BOXING BEAR BREWING COMPANY
NEW SHADE CANOPY
12501 CANDELARIA ROAD NE
ALBUQUERQUE NM 87112

TO: Treveston Elliott Architect
FROM: Leroy Duarte, Staff Planner
City of Albuquerque Planning Department
TEL: (505) 924-3452
RE: AA PR-20219-002237 12501 Candelaria Rd. NE- Bridges on Tramway

I am the Staff Planner reviewing your application for project #2019-002237, an Administrative Amendment at 12501 Candelaria Rd. NE for a shade canopy over existing patio on site.

Cold Formed Steel:

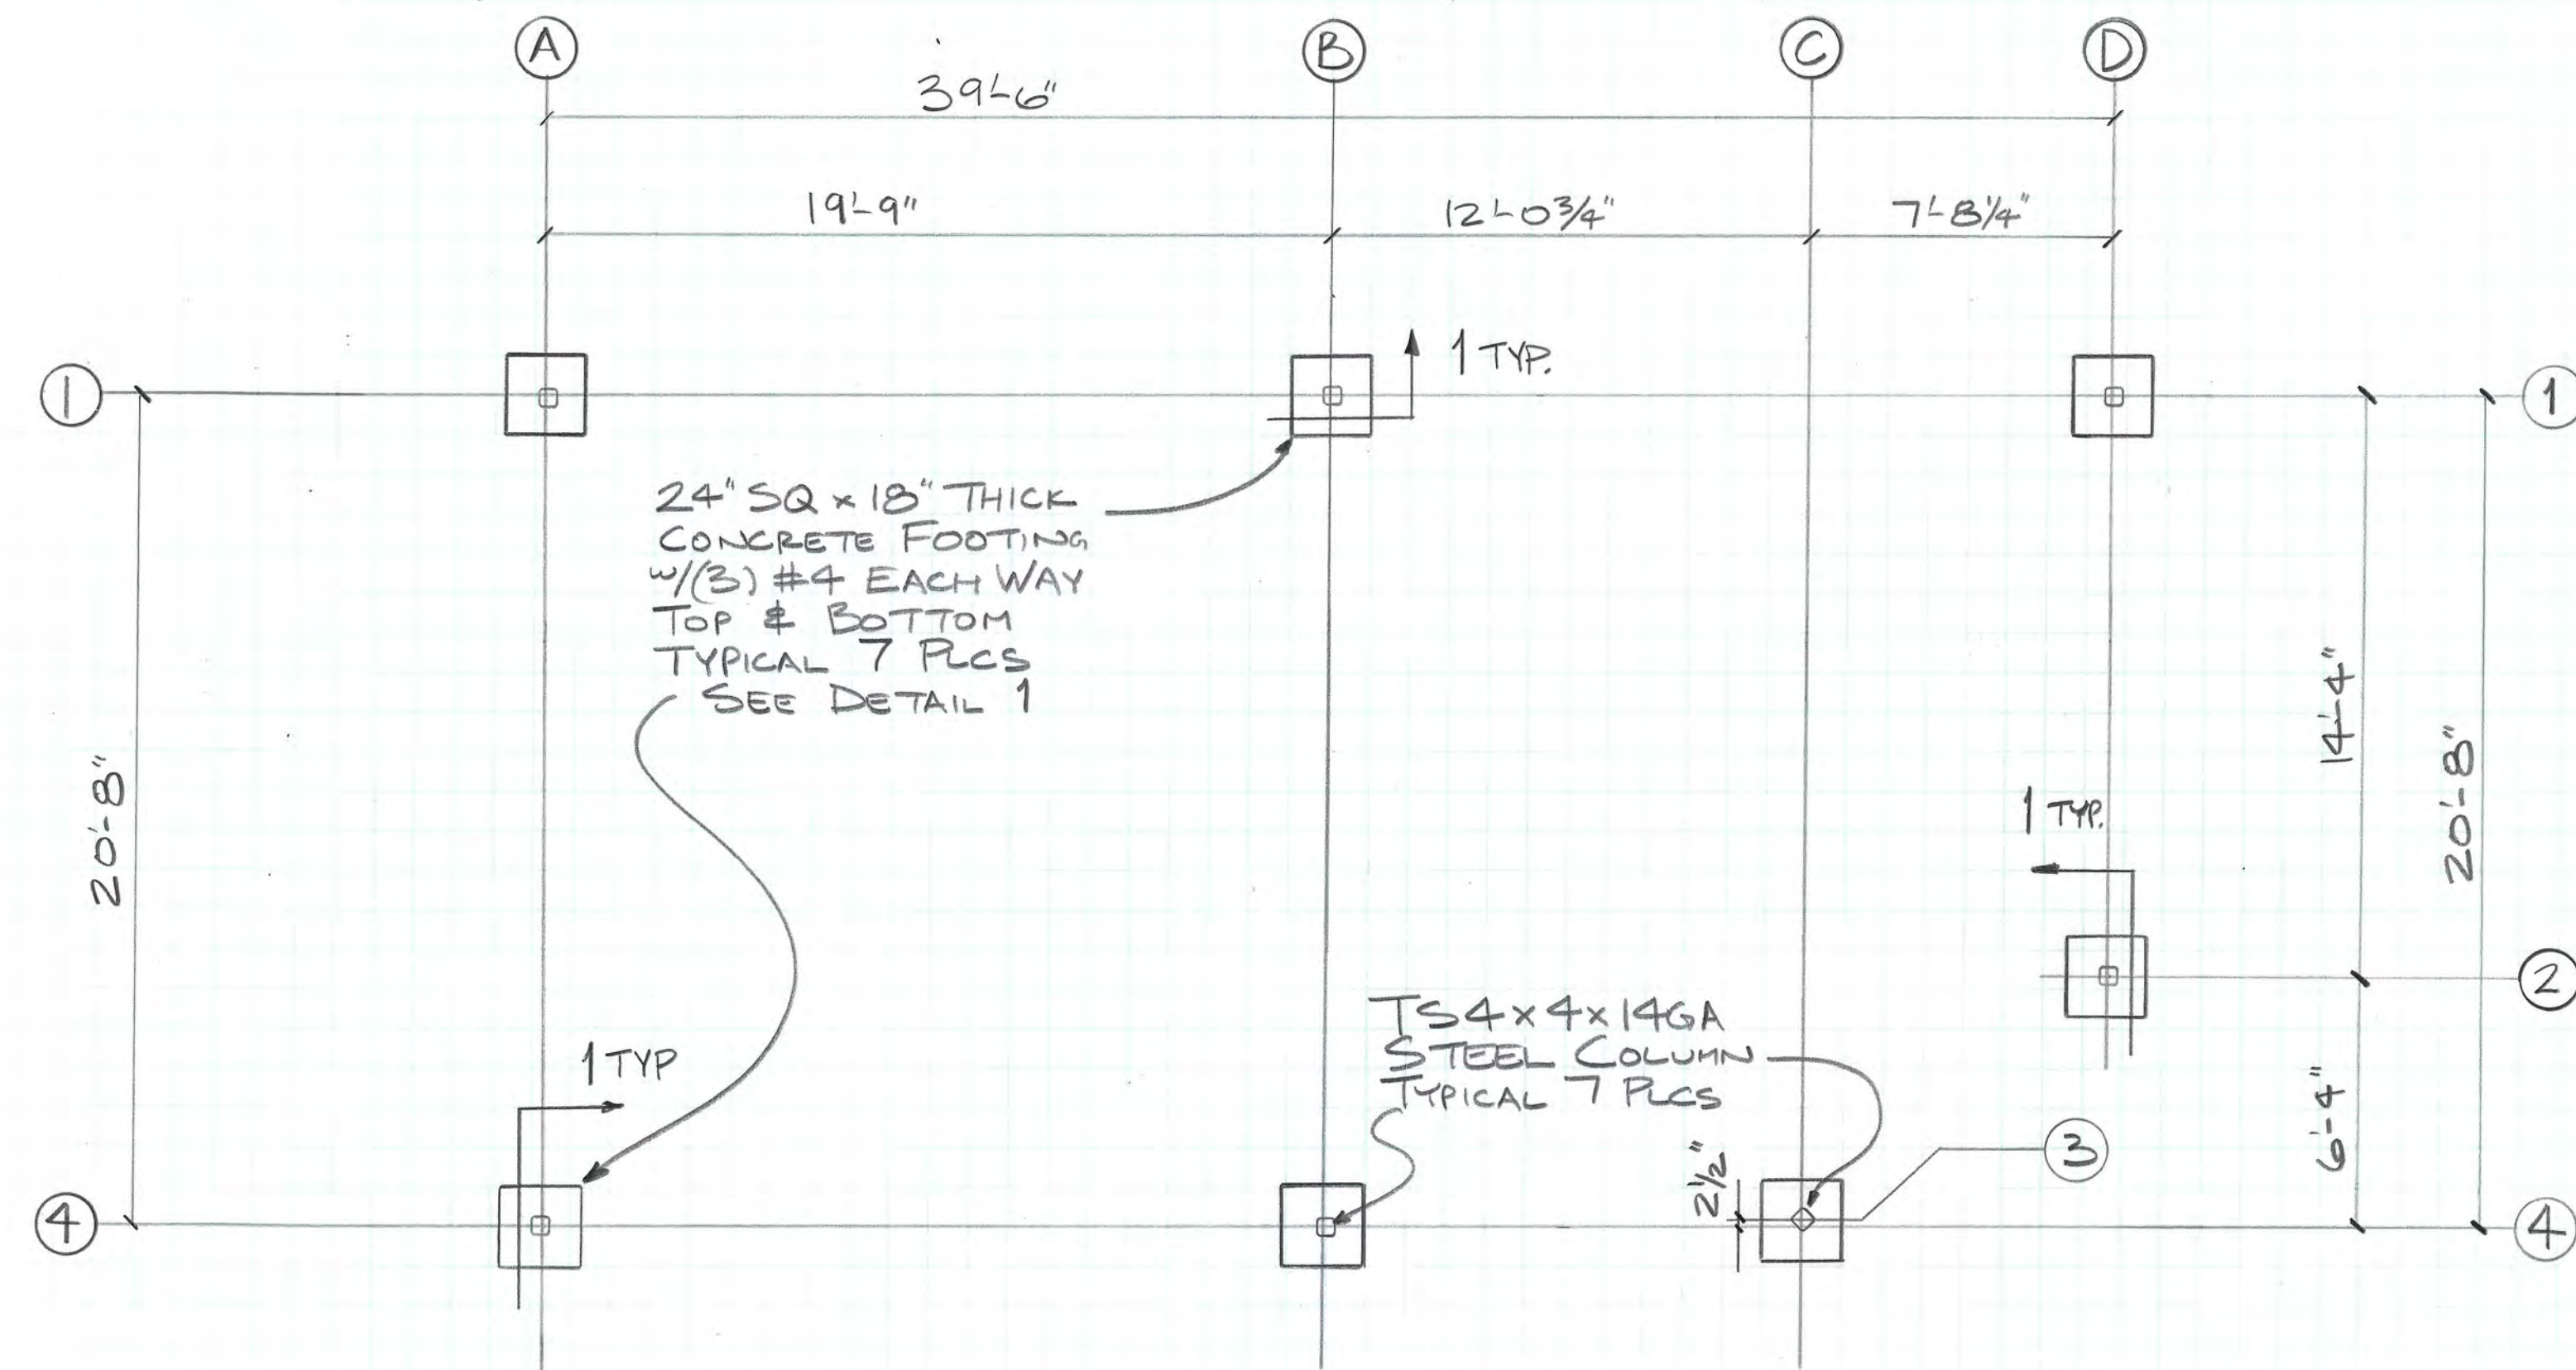
Please show proposed covered patio drawings/details.
